FNDC - PROPOSED DISTRICT PLAN

COASTAL ENVIRONMENT, NATURAL CHARACTER & OUTSTANDING NATURAL LANDSCAPES

FOR: FAR NORTH DISTRICT COUNCIL

5 July 2024

Figure 1 Proposed Maori Purpose Rural Settlement zone taken from p12 of the submission

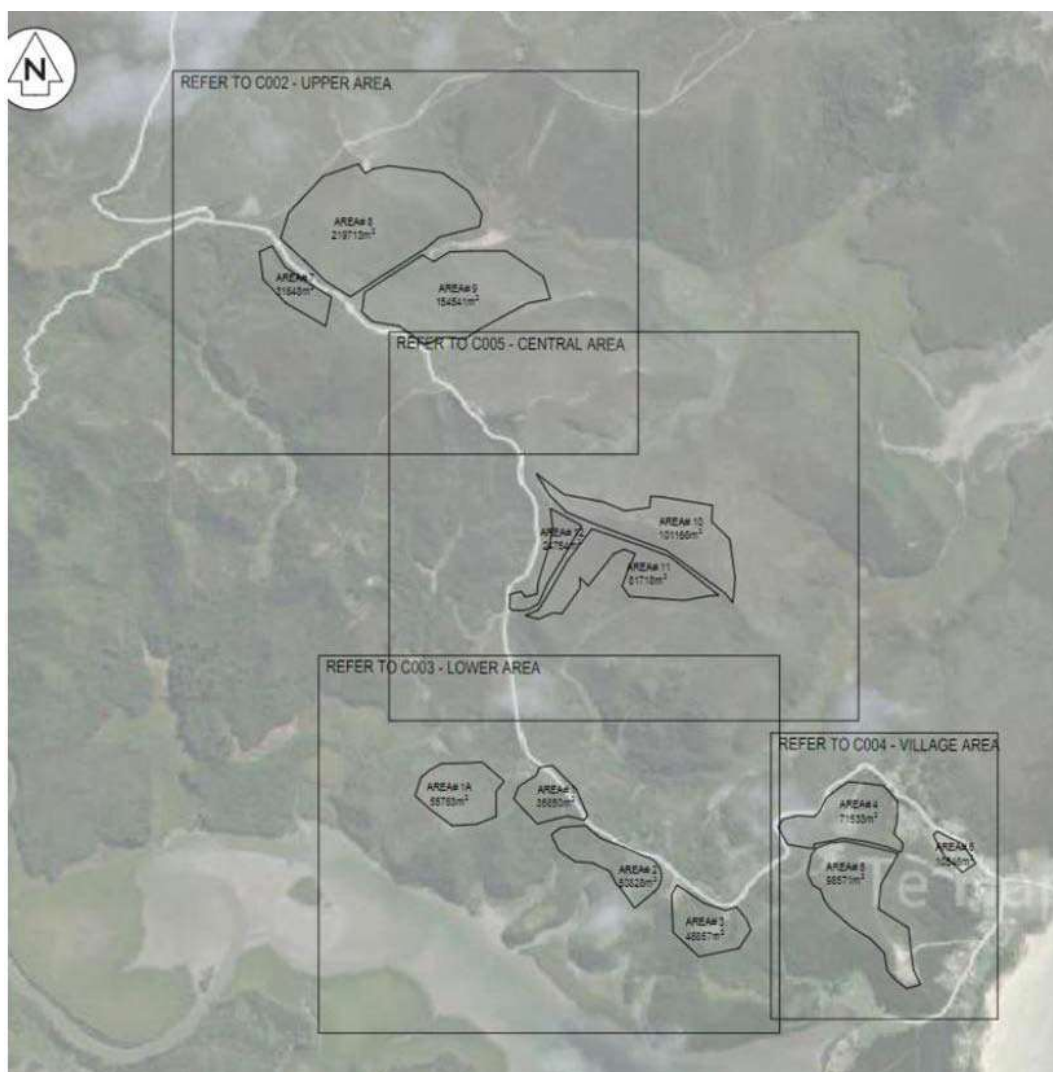
Specifically, in s420.007 they seek removal of the ONL overlay from that part of their land that they propose be re-zoned Māori Purposes Rural Settlement zone, illustrated in **Figure 1** below. Having carefully reviewed the PDP maps relating to Te Hāpua, I can confirm that there are no ONLs over the area illustrated.

Figure 2 Excerpt from PDP maps with ONL overlay over aerial photography. The forestry areas referred to above are highlighted in blue

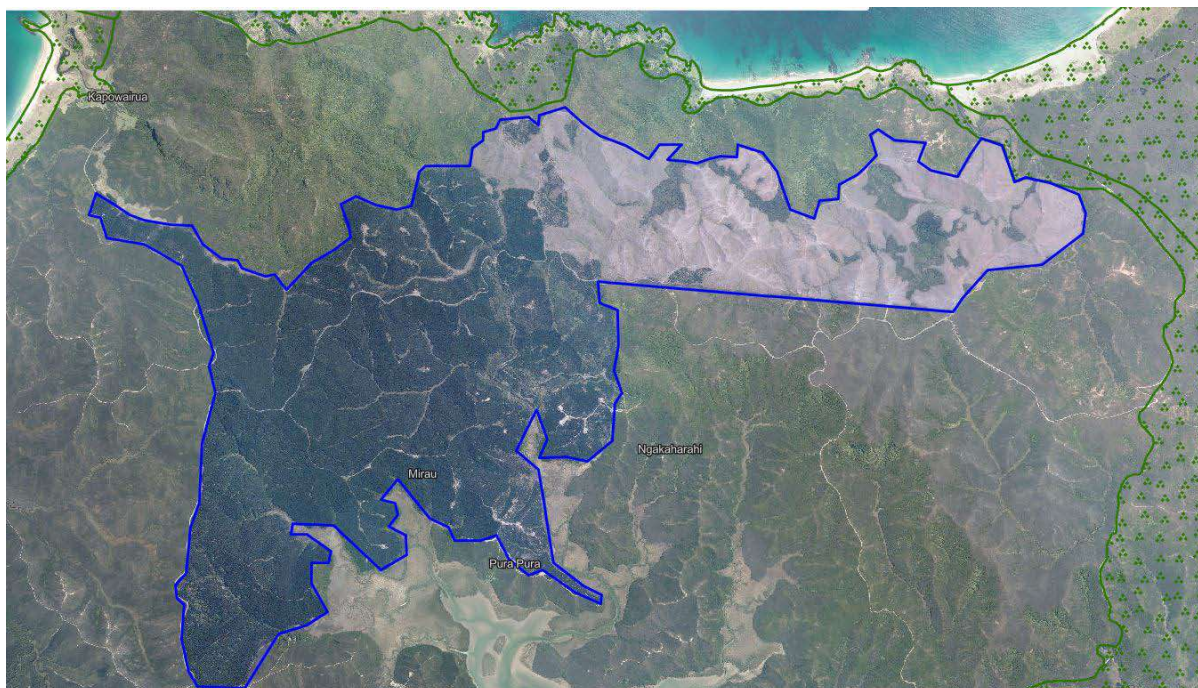
Submission point s420.009 seeks the removal of the ONL "from that part of the Te Hāpua and Shenwood Forests that is greater than 500m from the coast." Although not defined in the submission, the areas of forestry referred to would appear to be those lying immediately east of Spirits Bay Road, as illustrated in the polygon in **Figure 2** below.

As can be seen, there is no ONL overlay over the areas of forestry.

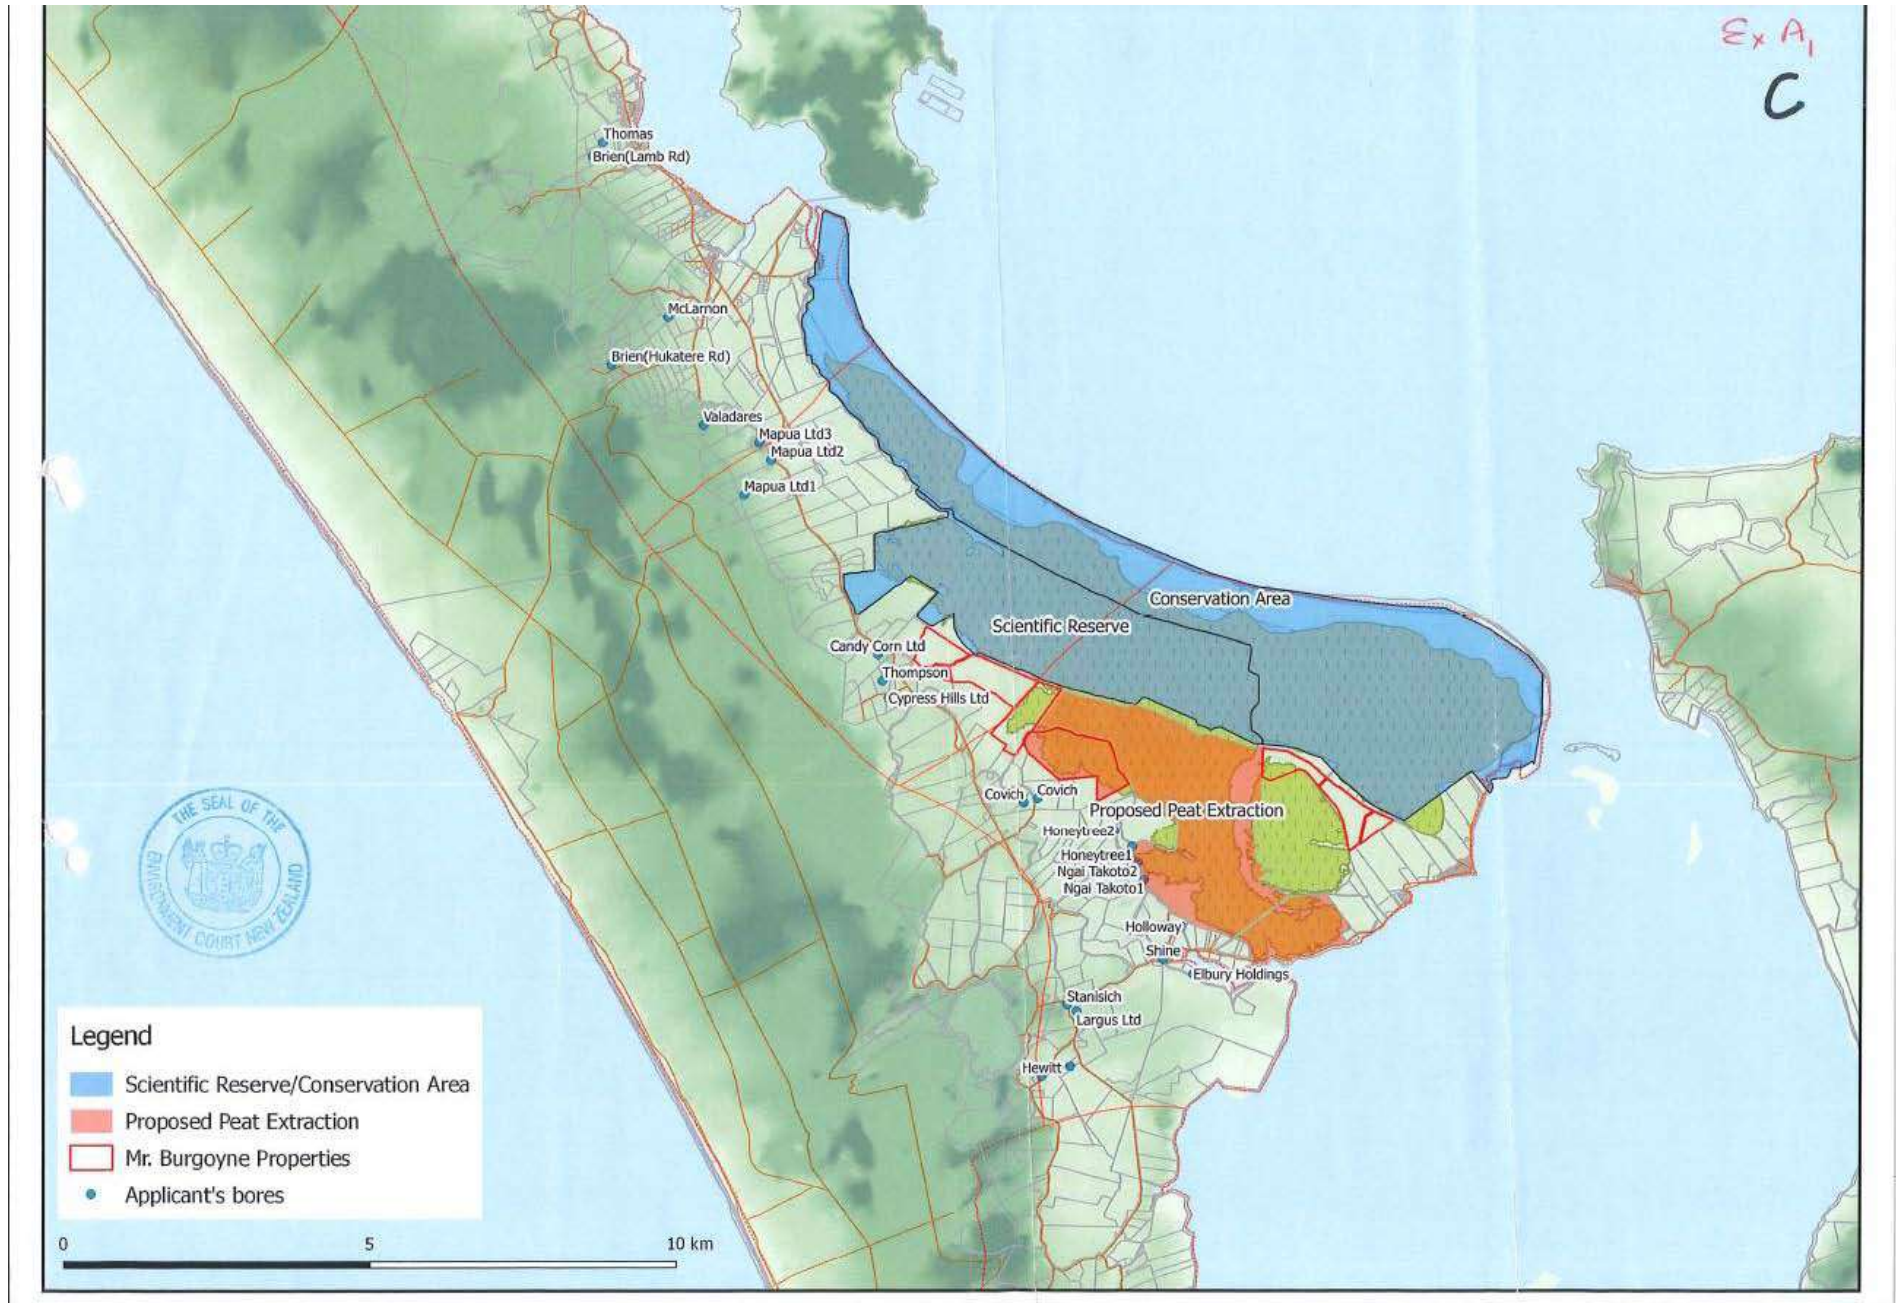
The Map B referred to in the decision is included overleaf. The key on the map shows that the topography of the wetland in metres above sea level is illustrated in bands of colour.

The landward edge of the CE as mapped in the RPS and PDP appears, from aerial photography, to follow a change in vegetation type or height and sits more or less consistently at about 1km from the coastal edge.

Although the Environment Court decision is somewhat ambiguous about which bands of colour in Map B it is referring to, it nevertheless concludes that both the Scientific Reserve and Conservation Area (together called the Reserve Area) is within the CE. I have also included Map C from the Environment Court decision, as this more clearly identifies the boundaries of the Scientific Reserve and the Conservation Area.

Figure 4

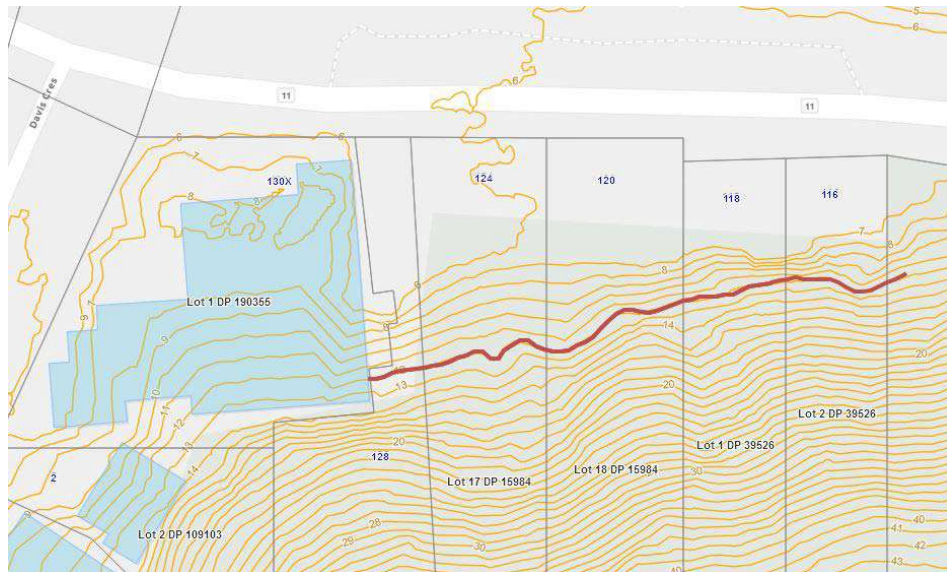
As can be seen from the two maps overleaf, the edge of HNC 426 does not extend down to the bottom of the coastal escarpment but leaves the bottom vegetated slopes free of the overlay.

Figure 4 below shows the site and 12m contour in red, as shown in the FNDC property and land maps.

Figure 6 Part of HNC 422 at the southern end of the subject property.

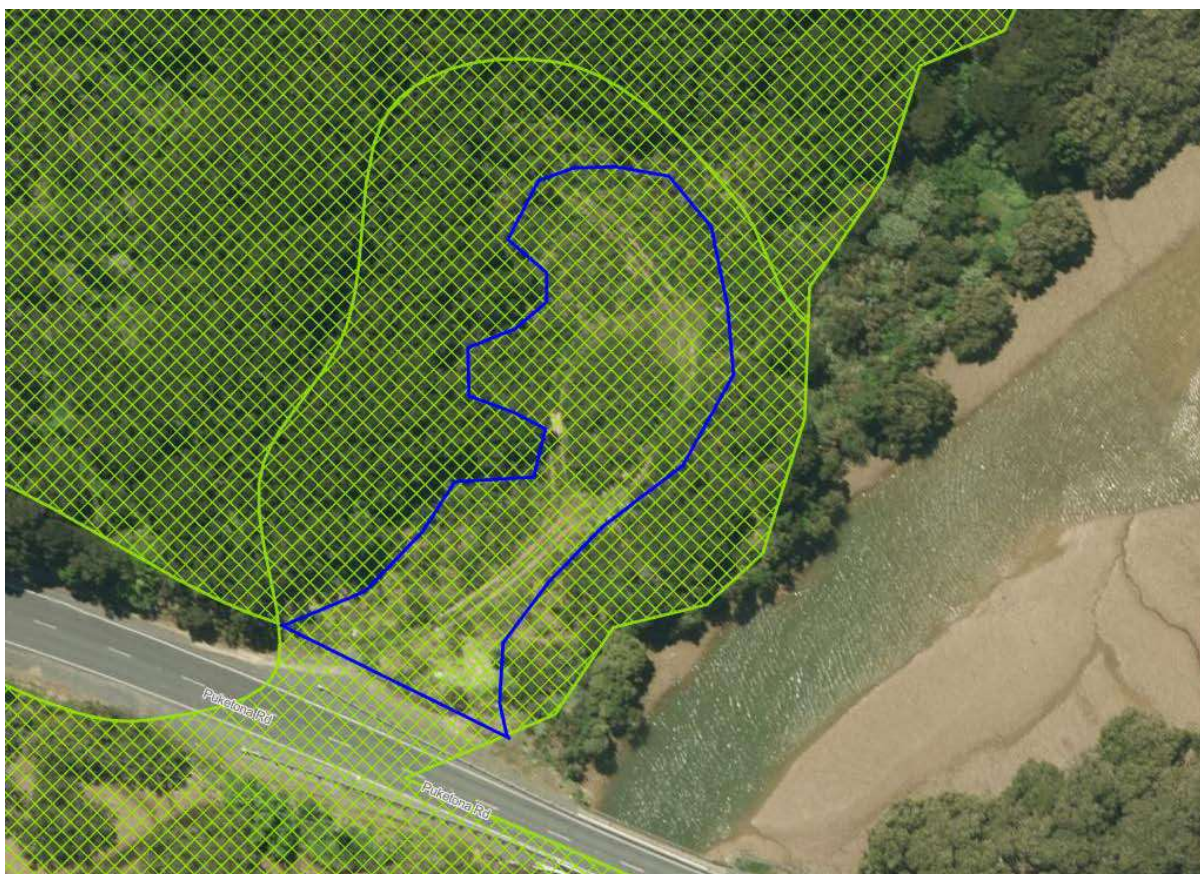
Having observed the lower portion of the subject property from the road, I consider there may be some justification in removing part of the small projection of HNC422 from the property. This area of the site is clear of native vegetation and does not fit the description in Appendix 7, provided above. I have included a plan showing the suggested trimming by means of a blue line in **Figure 6** overleaf.
